DOCUMENT CHANGE REQUEST

DCR number 270	Changes required for: General	Originator: Ron Fidler
Date: 2006/07/24	Date sent: 2006/07/24	Organisation: ESA/ESTEC
Status: IMPLEMENTED

Title:	Diode, Silicon, Power Rectifier, Schottky Barrier, based on Type STPS1045		
Number:	5106/017	Issue:	1

ESCC Detail Specification No. 5106/017

1.6.1 Surface Mount Package (SMD.5) - 3 Terminal

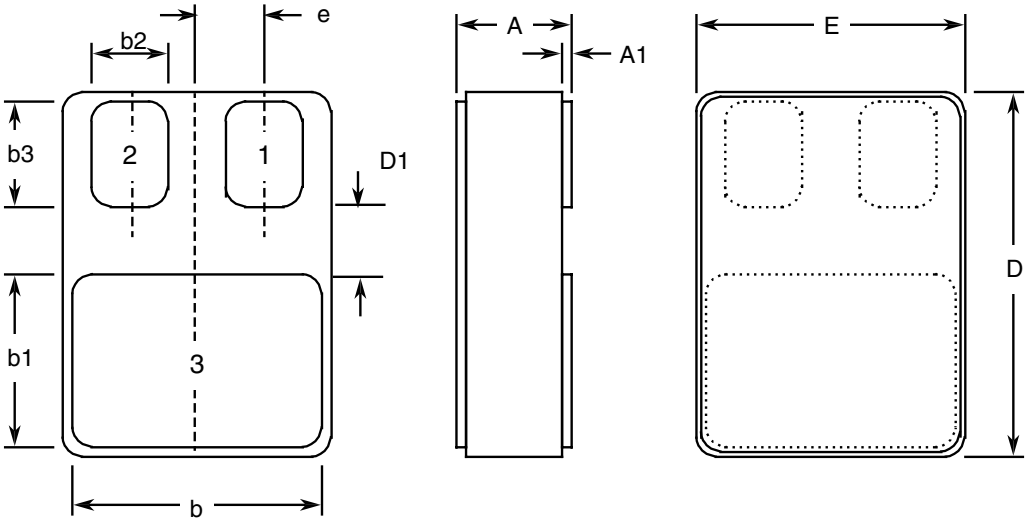
5. Figures 2 . Dimension .e. corrected from "Typical" to "BSC".

Symbols	Dimensions mm		Notes
	Min	Max	
A	2.84	3.15	
A1	0.25	0.51	
b	7.13	7.39	
b1	5.58	5.84	
b2	2.28	2.54	2
b3	2.92	3.18	2
D	10.03	10.28	
D1	0.76	-	2
E	7.39	7.64	
e	1.91 BSC		2
